**Office of Enterprise Assessments
Review of Waste Isolation Pilot Plant
Engineering and Procurement Processes**

November 2015

**Office of Nuclear Safety and Environmental Assessments
Office of Environment, Safety and Health Assessments
Office of Enterprise Assessments
U.S. Department of Energy**

Figure 1. Simplified Firewater Supply Diagram

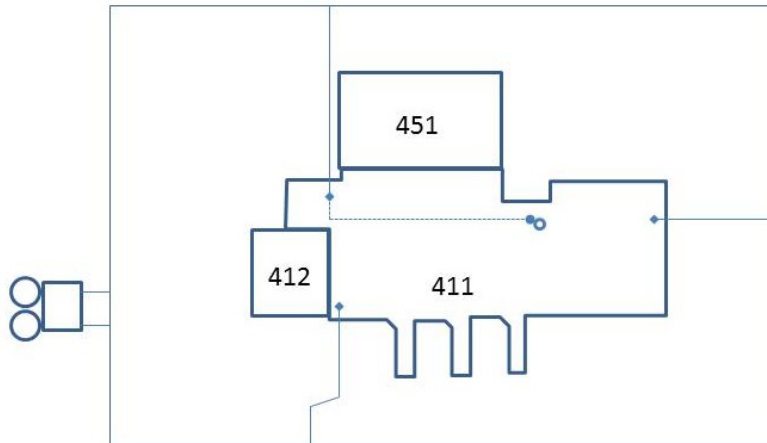
Note that the loop feeds three risers in the building, and the riser fed from the north side of the loop feeds the sprinklers for the Waste Hoist Tower.

Figure 2. Simplified Firewater Supply Diagram Showing Firewater Extension
The firewater extension is shown connecting the north and south risers.

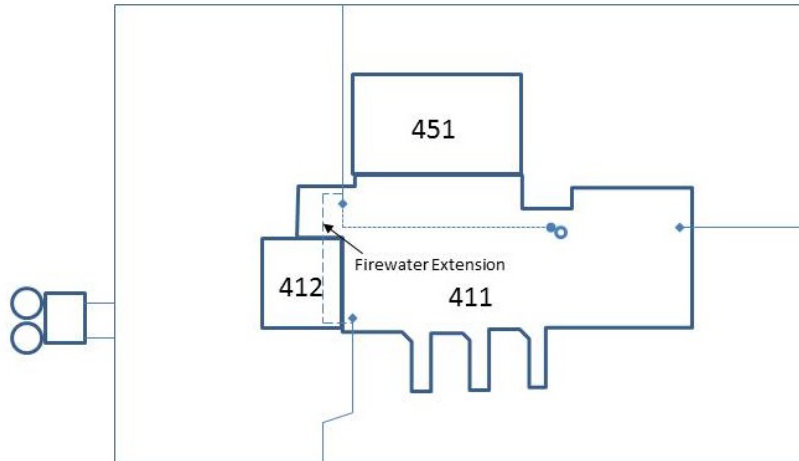
ECO 12037, *Fire Water Supply Extension Connection*, was prepared, approved, and installed to address an impairment impacting the south fire suppression system riser. The ECO provided a 6" diameter pipe to supply water between two separate risers (north and south) in Building 411. Figure 2 shows the firewater extension. Calculations at the time showed that bringing in water from the north riser's supply would be sufficient to meet the demand at the areas served by the south riser. An unreviewed safety question (USQ) screening was performed and documented as USQS-08-493, *ECO #12037 and WO #0804244M, Install Fire Water Supply Extension*. The USQ screening noted that applicable DSA and technical safety requirement (TSR) sections required "the fire suppression system in the WHB be supplied by three risers with specified valves locked open." The USQ screening also stated that "Incorporating this modification can result in one of the WHB fire suppression risers being supplied by an alternate source...during this time CH and RH LCO 3.1.1 cannot be met and DOE permission is required for continued operation. This alternate configuration was presented and approved by Justification for Continued Operation NS-RP-2008-02." However, the screening question "Does the proposed activity represent a change to the facility or procedures as described in the safety basis?" was answered in the negative. Likewise, the screening question "Does the proposed activity represent conditions (e.g., new or changed hazards) that have not been analyzed in the existing safety basis?" was also answered in the negative. No calculations were performed to evaluate the hydraulic adequacy of using the south riser's supply to meet demands in the areas served by the north riser, or to evaluate the impact of the new flow path to supply the Waste Hoist Tower sprinklers. The USQ screening concluded, "The proposed activity screens negative and no USQD [USQ determination] is required."

Figure 3. Firewater Flow Path Analyzed in ECO11286
The analyzed flow path is shown with bold lines.

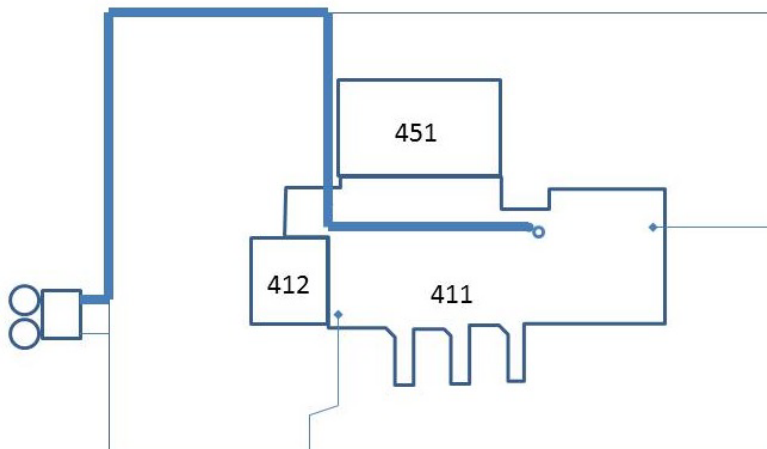
ECO 11286, *Calculation - Pressure and Flow for Hoist Tower Sprinklers*, was performed several years before the installation of the firewater supply extension connection on ECO 12037. The calculation addressed the highest elevation protected by the safety significant fire suppression system, and examined the ability of the aging pumps to supply that location with adequate water.

The sprinklers at the top of the Waste Hoist Tower are fed from the north riser. When the hydraulic calculation was performed, it used the non-conservative shortest path around the Building 411 fire suppression supply loop, as depicted in Figure 3. A USQ screening did not identify this shortcoming. Although the calculation in ECO 11286 resulted in meeting performance requirements, little operating margin remained.

Figure 4. Firewater Route to Waste Hoist Tower due to Impairments

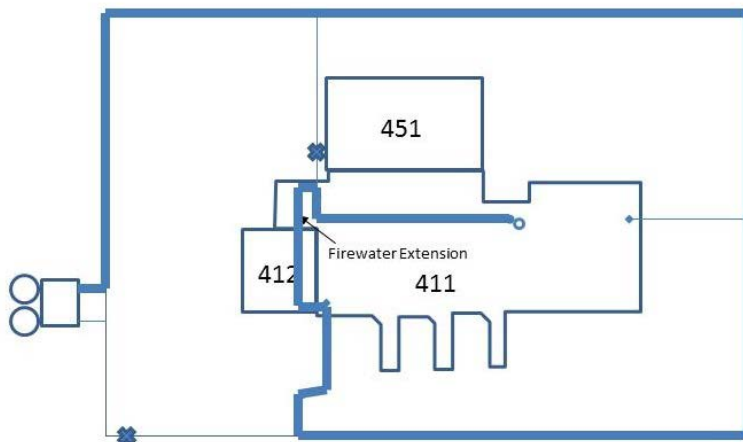
Subsequent impairments in the fire suppression system supply piping have resulted in the north riser now being supplied from the south riser's supply. This mode of operation was not analyzed when ECO 12037 was processed. In addition, a second impairment on the Building 411 fire suppression supply loop requires water to travel most of the loop before it reaches the south riser supply point. Figure 4 illustrates

the impairments that existed in August 2015, along with the path of firewater supply to the Waste Hoist Tower. This combination of impairments has placed the supply to the Waste Hoist Tower far outside of what has been analyzed. (See **Finding F-NWP-03.**) When informed of this issue by EA, NWP declared a potential inadequacy in the safety analysis (PISA).

Impairments on the southwest portion of the loop and the branch line feeding the north riser are identified with an X.

In addition, ECO 11286 is the basis for the pressure used in TSR surveillance requirement (SR) 4.1.1.7, “Pump Output - To provide the necessary amount of fire water to the sprinkler systems, each fire pump must be capable of pumping $\geq 1,500$ gpm at ≥ 105 psig (ECO 11286). This SR verifies on an annual basis that the fire pumps can perform this function. The annual frequency meets the requirements of NFPA [National Fire Protection Association] criteria.” Since the calculation used non-conservative values for determination of pressure loss, the adequacy of the TSR SR cannot be assured. (See **Finding F-NWP-04.**) (See **OFI-NWP-05.**)
